UNITED STATES PATENT AND TRADEMARK OFFICE

APPLICATION NO.	FILING DATE	FIRST NAMED INVENTOR	ATTORNEY DOCKET NO.	CONFIRMATION NO.
09/788,420	02/21/2001	Oh Nam Kwon	8733,388.00	5851
30827 7590 11/19/2010 MCKENNA LONG & ALDRIDGE LLP 1900 K STREET, NW WASHINGTON, DC 20006				
EXAMINER				
RUDE, TIMOTHY L				
ART UNIT		PAPER NUMBER		
2871				
MAIL DATE		DELIVERY MODE		
11/19/2010		PAPER

Office Action Summary

DETAILED ACTION

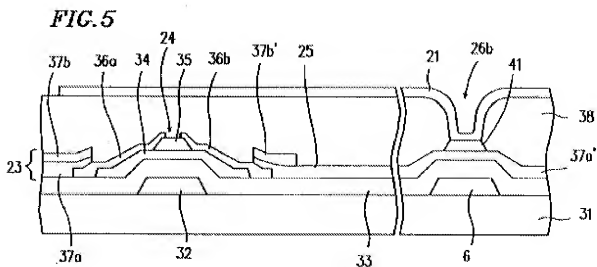
As to claims 1, 8-9, and 28, APA discloses a liquid crystal display (LCD) device (Fig. 1E) having a substrate (10), a first conductive layer (12A with no 12B; 12B is optional per Applicant's specification, page 9, per amendment filed 08 May 2007) and a pad layer (14A) on the substrate, wherein the first conductive layer and the pad layer

are patterned from the same conductive layer; a first insulating layer (16) on the substrate, the first conductive layer and the pad layer, the first insulating layer having a contact hole (above 14A) exposing a portion of the pad layer; (allowing electrical connection to 14A via contact hole above 14A);

a second insulating layer (26) on the third conductive layers, the second insulating layer having a first contact hole exposing a portion of the third conductive layers (contact hole for pixel electrode) and a second contact hole (hole for 30) exposing the portion of the pad layer through the first insulating layer,

a first adhesion conductive layer, 24B, on the exposed portion of a third conductive layer and a second adhesion conductive layer, 14B, on the exposed portion of the pad layer, wherein the first adhesion conductive layer is directly contacted with the third conductive layer and the second adhesion conductive layer is directly contacted with the pad layer [per APA Figure 1E];

a fourth conductive layer (28) on the second insulating layer and the first adhesion conductive layer and electrically contacting a portion of a third conductive layer;

a fifth conductive layer (30) on the second insulating layer and the second adhesion conductive layer and electrically contacting the pad layer.

APA does not explicitly disclose an embodiment wherein the first and second adhesion conductive layers are respectively contained within the first contact hole and in the second contact hole.
